ADDENDUM # 2

Re: PIN 072201634CPD for Emergency Generator for Transformer Servicing at the Samuel Perry Building, Gas House and Parking Lots on Rikers Island

SKE-101-1
 10/12/16

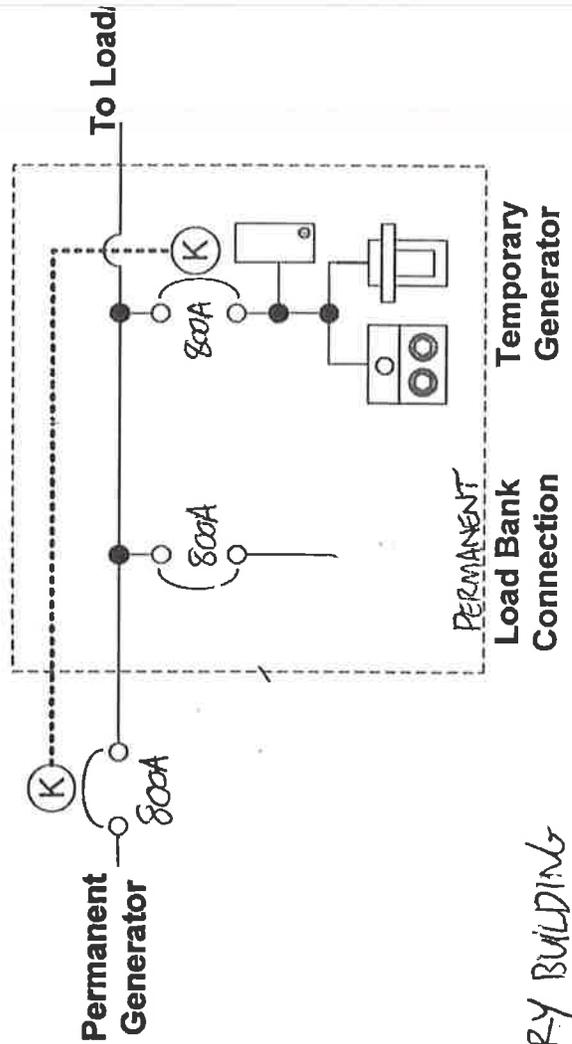
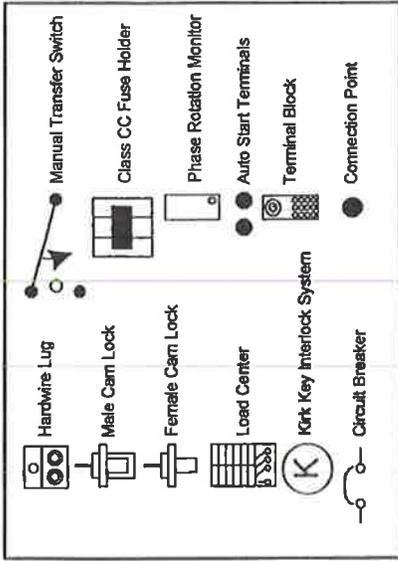
(See attached sketch for connection details)

Question 6: The “docking station” shown on E101 is not electrically correct. The means of connection would allow for the potential paralleling of the generator set, and a temporary generator set. They need to have a better design, which would ensure that the two units cannot parallel. This can be done either through a manual transfer switch, or through breakers with kirk key interlocks, which would not allow both to be closed simultaneously.

Answer 6: The contractor should provide breakers with kirk key interlocks to avoid paralleling.

TRYSSTAR
Dual Breaker Docking Station Dual
Purpose Pass Through with Hardwire
and Kirk Keyed Breaker
